# MEMORANDUM

**TO:** Christopher Ketchen, Town Manager, Lenox, MA

**SUBJECT:** Weston & Sampson Review of Rest of River On-Site and Off-Site Transportation and Disposal Plan

**FIGURE 2**  
**HOUSATONIC RIVER,**  
**PRIMARY STUDY AREA**  
**(REACHES 5 AND 6) AND**  
**REACHES 7 AND 8**

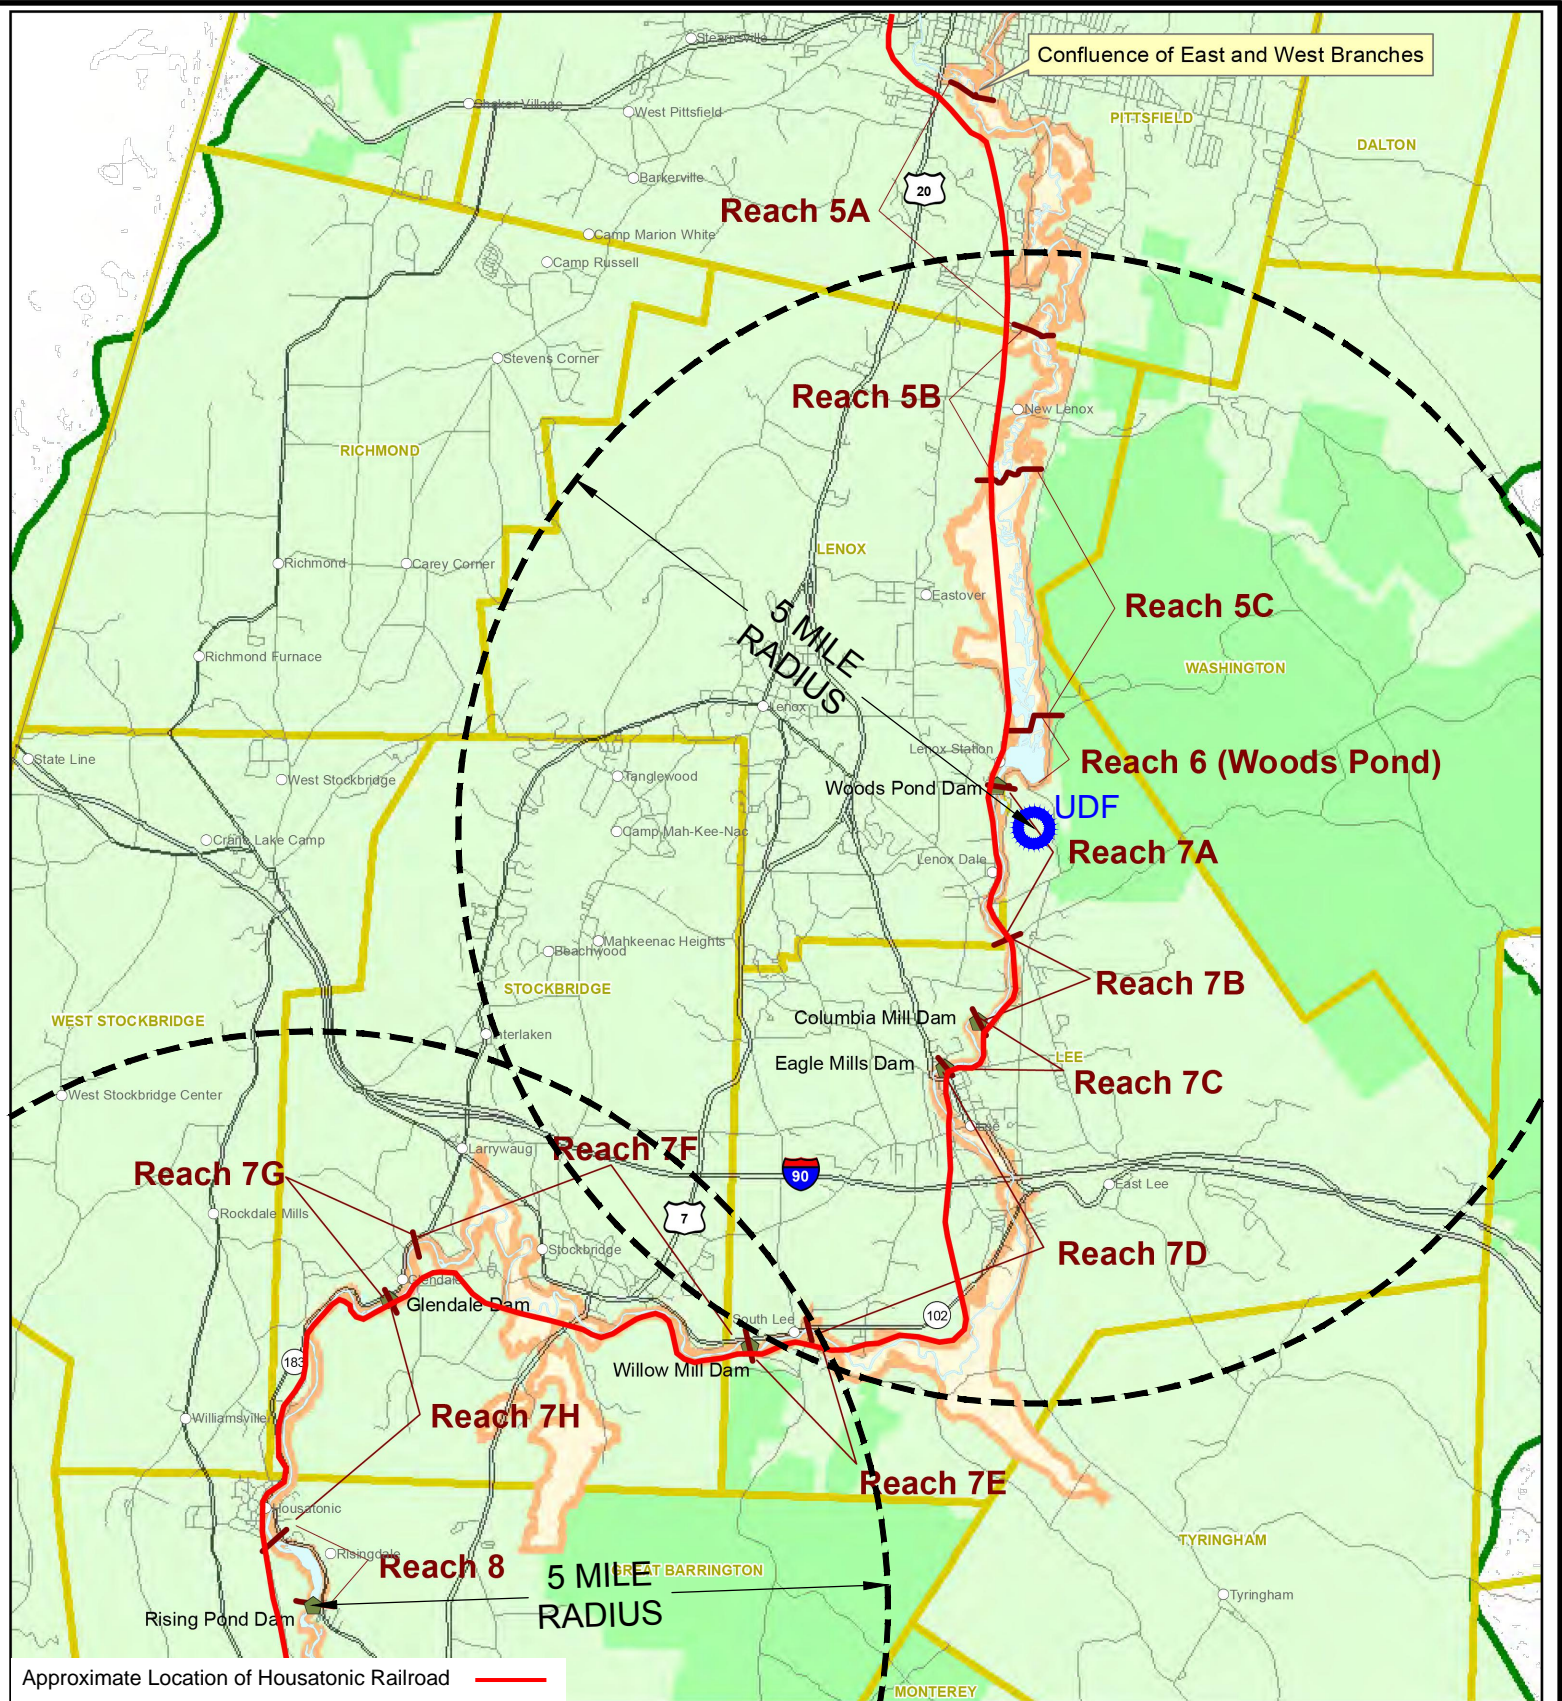
As seen on Table 2-1, nearly 65% of the total volume of planned removal materials will be from RUs 5C and 6. These RUs are located immediately to the north of the UDF (see the attached modified Figure 2 from the T&D Report) and there is mention in the report that hydraulic dredging will be considered for use and employed, if feasible, in these RUs. Table 3-1 in the T&D Report indicates that an estimated total of 590,000 CY will be conveyed by hydraulic conveyance, if feasible. This represents approximately 88% of the total volume to be removed from these two RUs and the use of hydraulic dredging and conveyance creates a potential for a large reduction in trucks used to move dredged sediments.

Looking at the modified Figure 2, most of the RUs along the southern section of the Housatonic River dredging project are within five miles of this rail siding. It is requested that GE do further evaluations of hydraulic dredging and conveyance of dredged materials to this location for staging, processing, and eventual rail transport to the UDF. Again, this would greatly decrease the need for off-road and on-road trucking of dredged materials and decrease the need for construction of staging areas and haul roads. There are other sidings along the Housatonic Railroad that could be used for the temporary storage of rail cars holding dewatered and treated sediments (see attached photographs).
